HISTORIC AND DESIGN REVIEW COMMISSION

June 07, 2017

HDRC CASE NO: 2017-192
ADDRESS: 1025 DAWSON ST NCB
LEGAL DESCRIPTION: 2872 BLK N LOT 6
ZONING: R-6 H
CITY COUNCIL DIST.: 2
DISTRICT: Dignowity Hill Historic District
APPLICANT: Richard Gross
OWNER: Enrlour Investments
TYPE OF WORK: Exterior modifications, window fenestration modifications
REQUEST:

1025 Dawson Amendment

1025 Dawson Front + Back Views

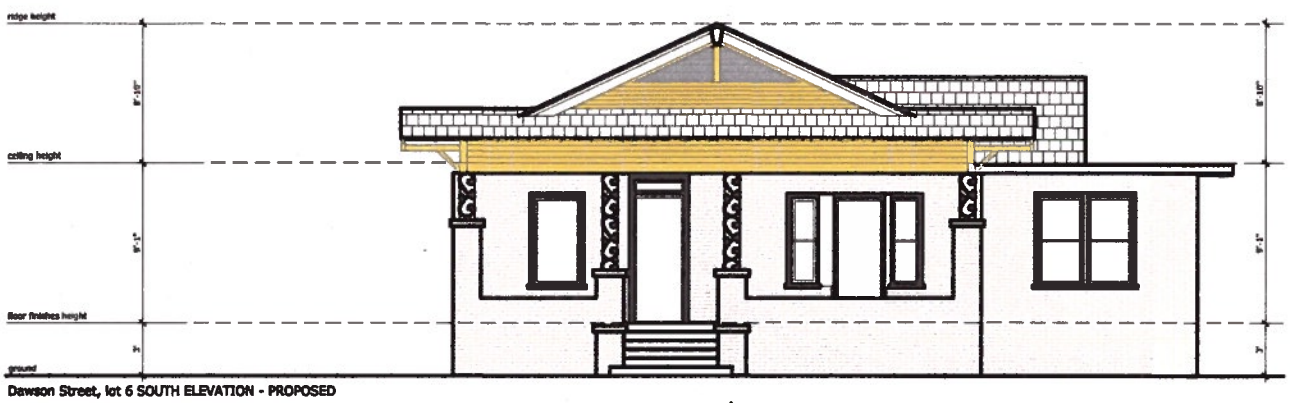
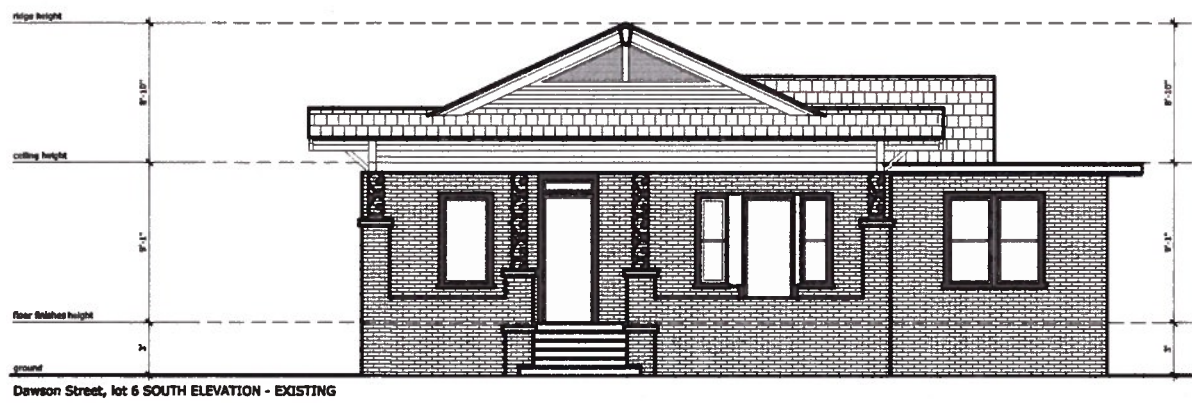
Front

No Change

Back

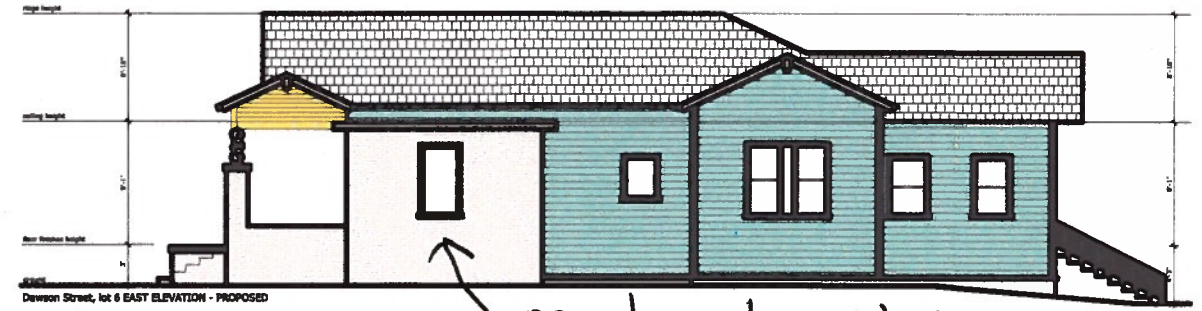
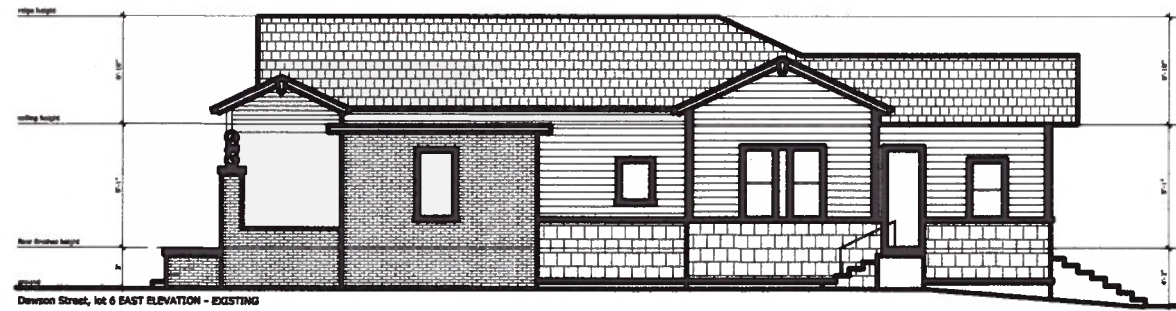
- b. **REAR FAÇADE MODIFICATIONS**– On the rear façade, the applicant has proposed to modify an existing door and window opening. The proposed modification is to occur on the rear façade of the original structure. Per the Guidelines for Exterior Maintenance and Alterations 6.A.1., historic window and door openings are to be preserved and should not be enlarged or diminished. The proposed modifications are not consistent with the Guidelines.

Remove window

Remove door + window + replace with sliding door

Staff does not recommend approval of items #1 and #2 based on findings b and e. Staff recommends the applicant maintain the rear façade arrangement and repair the existing windows.

- 1) Removal of Window on Addition Right Side of House
 - a. We will keep this original window in place
- 2) Back Deck Sliding Glass Door
 - a. Submitted new renderings that show the door not impacting the existing roofline and the gutter system to mitigate the rain fall

1025 Dawson Side Elevations

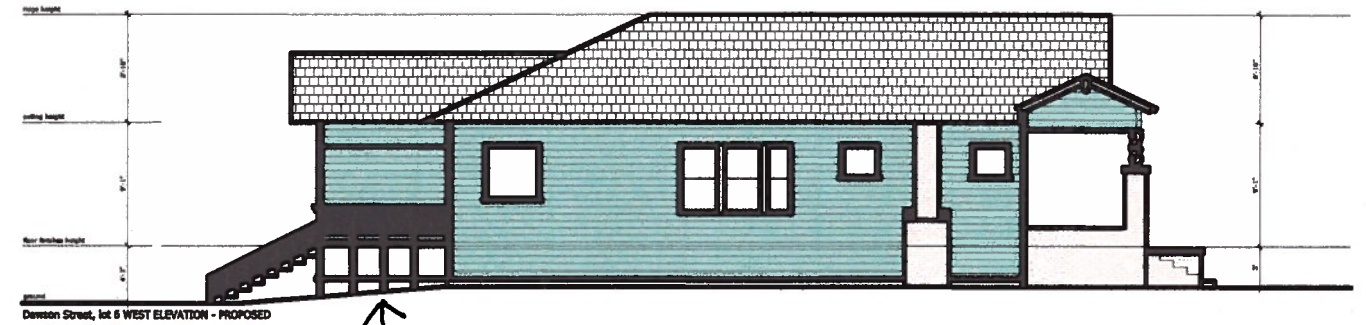
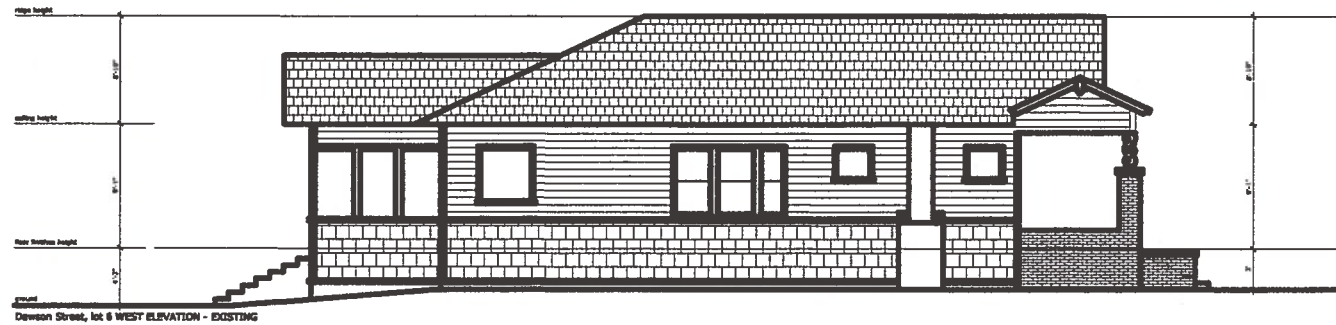
- c. **SIDE ADDITION MODIFICATIONS** – Per the Guidelines for Exterior Maintenance and Alterations 6.A.1., historic window and door openings are to be preserved. Staff finds the removal of the rear facing window appropriate given its location on a rear facing façade.

COMMENTS/CONCERNS: AK: DOESNT AGREE WITH THE REMOVAL OF
THE SIDE WINDOW; OPENING SHOULD BE RETAINED WITH NO OPAQUE
OR STAINED GLASS. EG: DOES NOT SEE A PROBLEM WITH THE
PROPOSED MODIFICATIONS TO THE REAR FACADE - AK IN AGREEMENT.
